ROCKY FLATS SITE

REGULATORY CONTACT RECORD 2014-08

Purpose: Provide flexibility to the flow configuration at the Solar Ponds Plume Treatment System (SPPTS) as part of the ongoing optimization effort.

Figure 1. Location of Excavation for Piping Installation

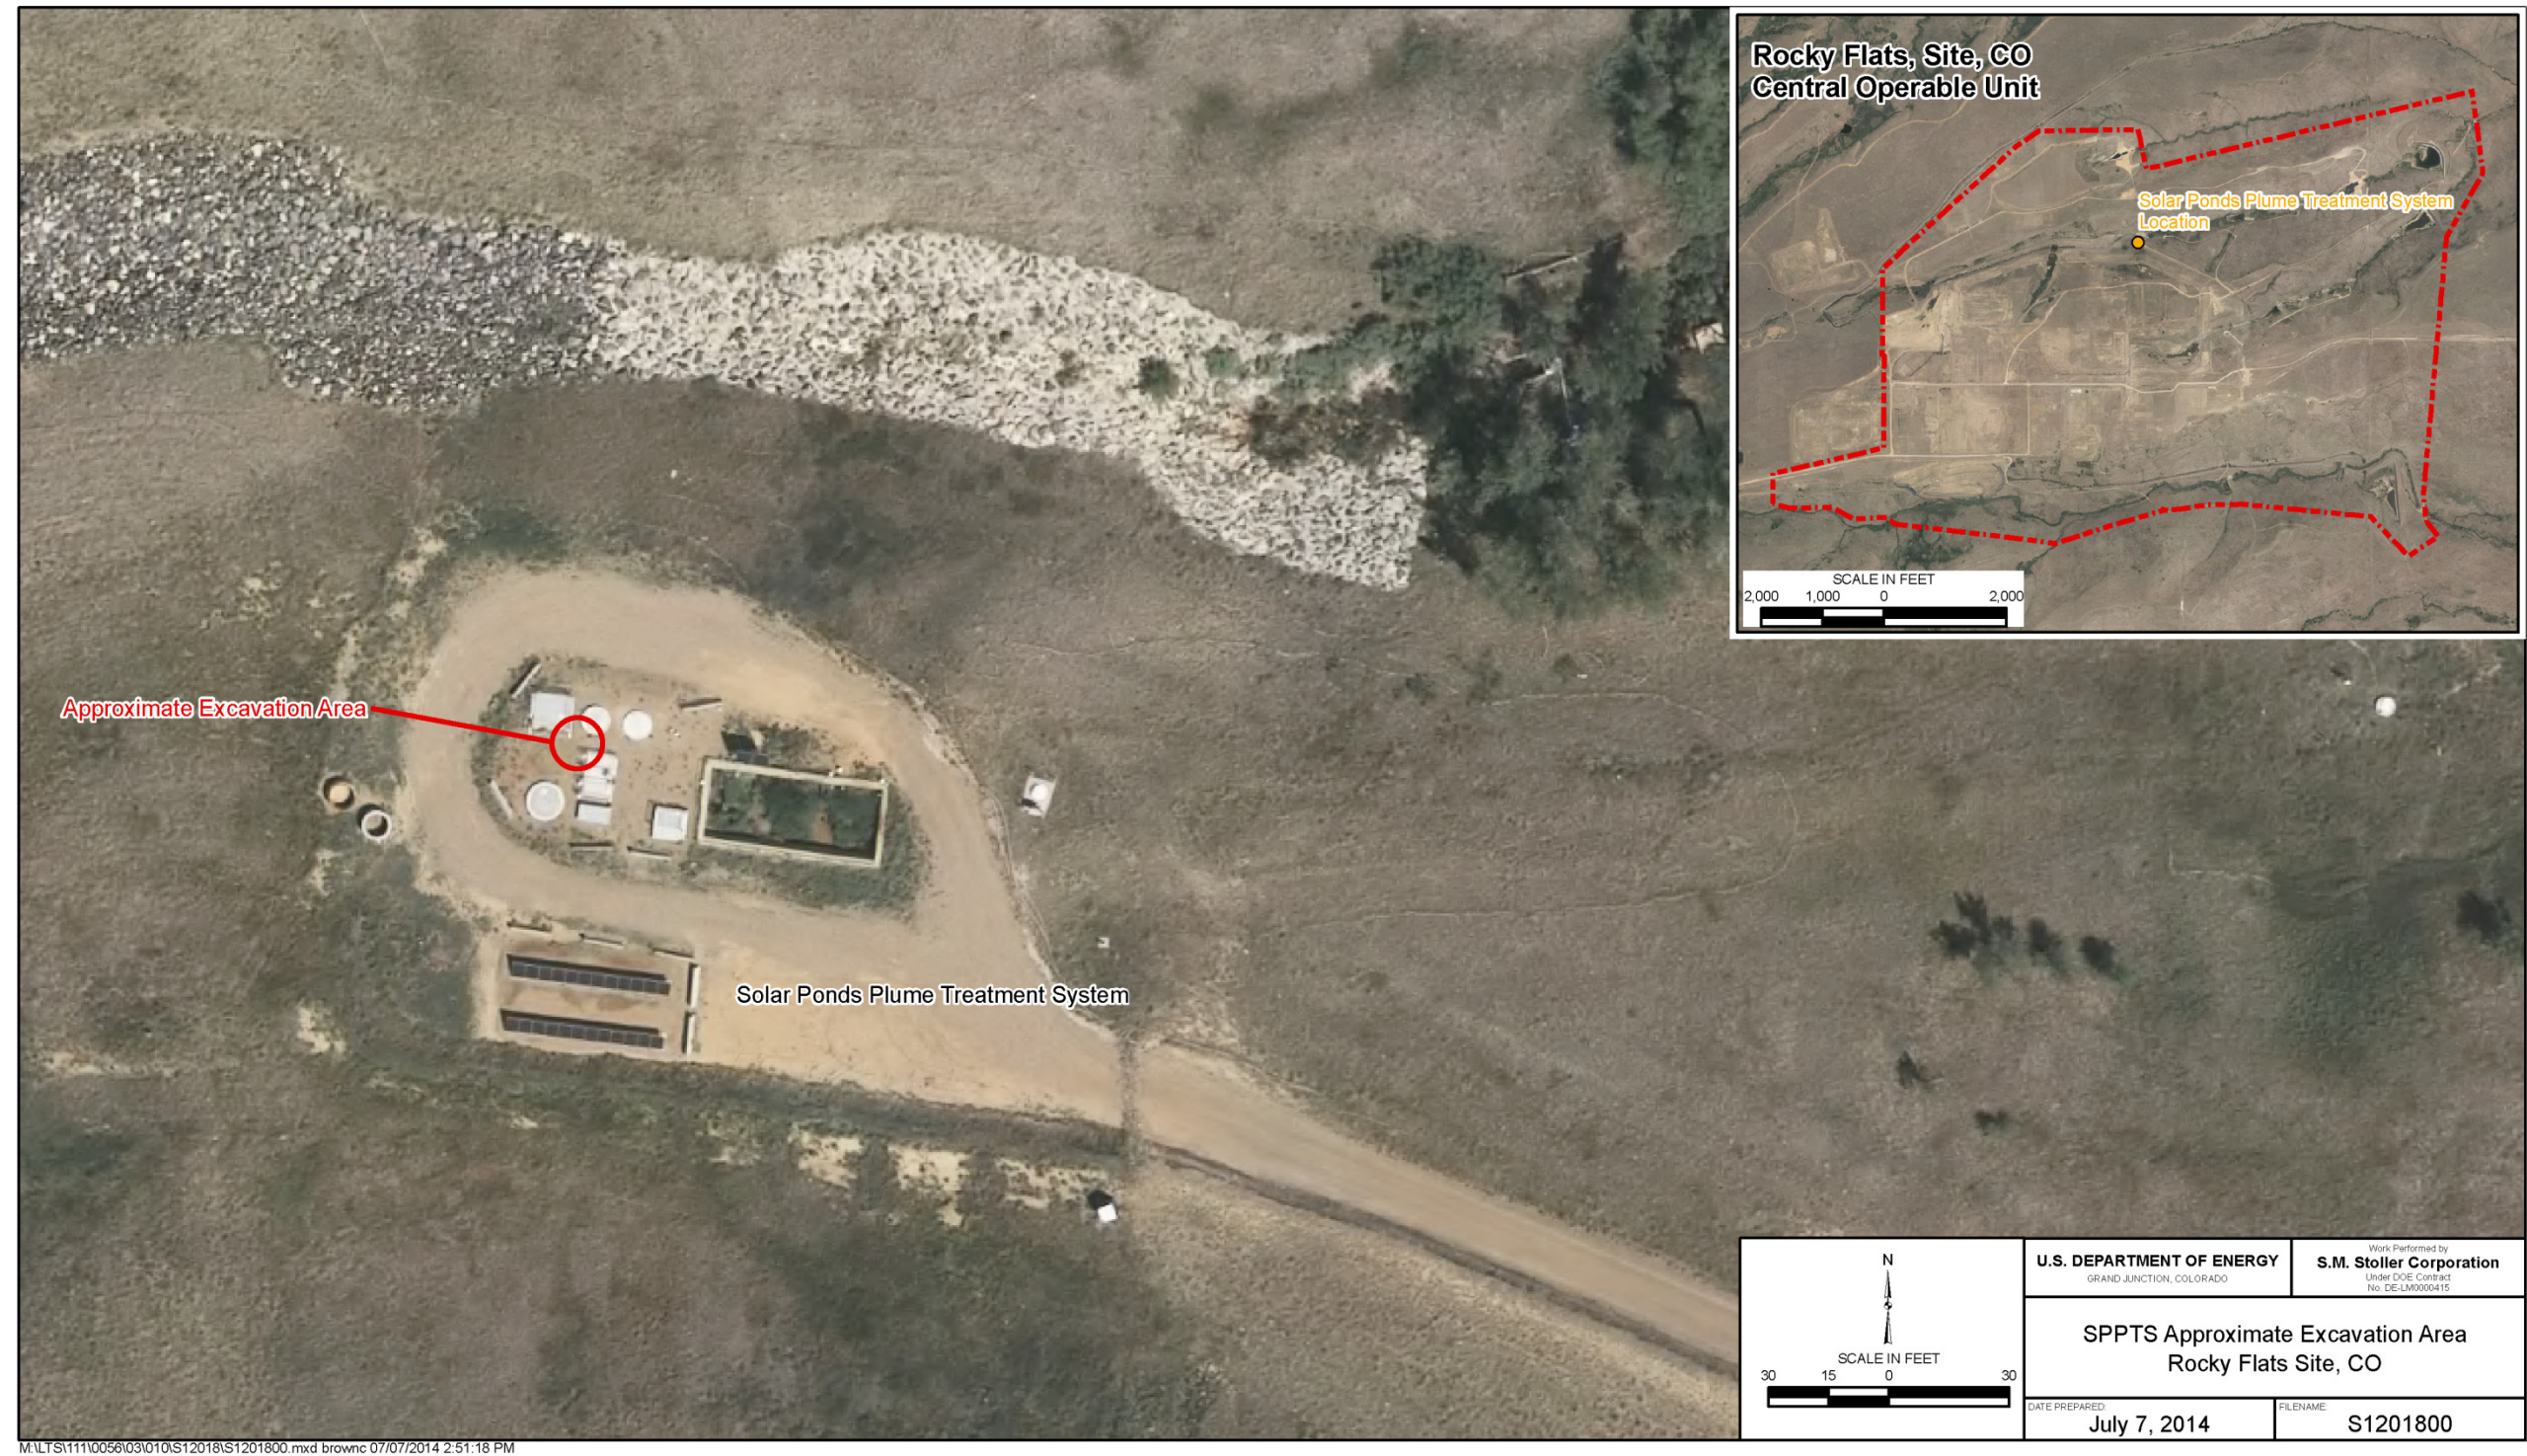
The soil disturbance that occurs during the excavation of existing piping is subject to the requirements of certain *Rocky Flats Legacy Management Agreement* (RFLMA) institutional controls (ICs), as discussed below. An approved Soil Disturbance Review Plan (SDRP) is required and the RFLMA parties agree that Figure 1 provides sufficient information for the SDRP for the proposed work.

A hole approximately 8 feet x 8 feet and 6 feet deep will be excavated to access the existing piping that requires modification to provide the needed flexibility. Figure 1 in Contact Record 2014-08 shows the location of the excavation and soil disturbance. This excavation is within the existing footprint and fill materials of the Phase II and Phase III upgrades to the SPPTS.

Resolution: CDPHE after reviewing information regarding the proposed soil disturbance and excavation and consultation with EPA, will approve, approve with modification or disapprove the proposed activity. CDPHE will determine if the proposed activity will not compromise or impair the function of the remedy or result in an unacceptable release or exposure to residual subsurface contamination. CDPHE will also determine if the proposed project meets the rationale and objectives of ICs 3 and 6.
